# Access Compliance Report

## Public Rights-of-Way

### (Curb Ramps)

Intersection ID: 31243	Main Street: NEWFANE_RD	Cross Street: DAVID_COX_RD	Location: SW
ADA ID: 98A7186EF92F	Ramp Type: Perp	Initial Pass/Fail: Fail	Overall Compliance: No
Severity Score: 10			
Codes/Mitigation Info/Possible Solution		Field Measurements/Component Compliance

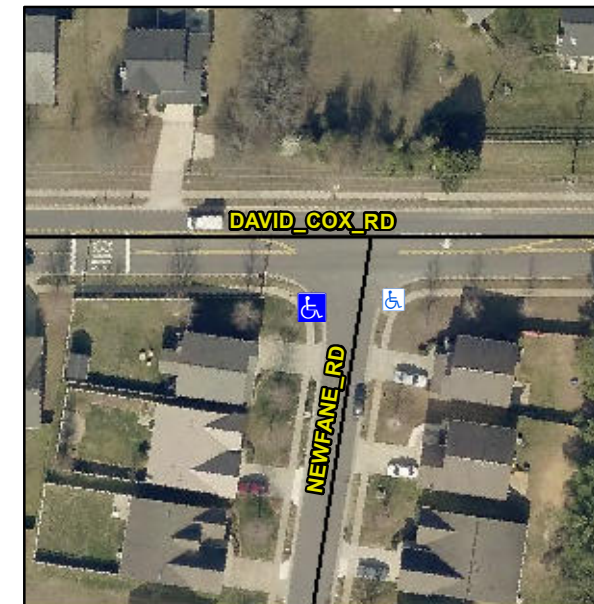
**Not Found, R304.5.1, R304.5.3**

Compliance	Description	Data	Compliance	Description	Data
N/A	Ramp Length (in)	48.0	Yes	Ramp Slope (%)	7.6
No	Ramp Width (in)	43.0	No	Ramp XSlope (%)	2.9
N/A	Flare Type LT	N/A	N/A	Flare Type RT	N/A
N/A	Flare Slope LT (%)	N/A	N/A	Flare Slope RT (%)	N/A
N/A	Flare Traversable LT?	N/A	N/A	Flare Traversable RT?	N/A
N/A	Landing Length (in)	N/A	N/A	DWS Provided?	N/A
N/A	Landing Width (in)	N/A	N/A	DWS Contrast?	N/A
N/A	Landing Slope (%)	N/A	N/A	DWS Length (in)	N/A
N/A	Landing X Slope (%)	N/A	N/A	DWS Full Width?	N/A
N/A	Landing Curb? (Y/N)	N/A	N/A	DWS Offset (in)	N/A
N/A	Shared Landing?	N/A			
N/A	Gutter Ponding?	N/A	N/A	Gutter Slope (%)	N/A
N/A	Gutter Lip Ht (in)	N/A	N/A	Gutter X Slope (%)	N/A
N/A	Painted X Walk1?	No	N/A	Painted X Walk2?	N/A
	X Walk 1 Direction	To E		X Walk 2 Direction	N/A
N/A	X Walk 1 Width (in)	N/A	N/A	X Walk 2 Width (in)	N/A
	X Walk 1 Slope (%)	4.9		X Walk 2 Slope (%)	N/A
	X Walk 1 X Slope (%)	2.3		X Walk 2 X Slope (%)	N/A

**Remove & Replace Entire Ramp.**
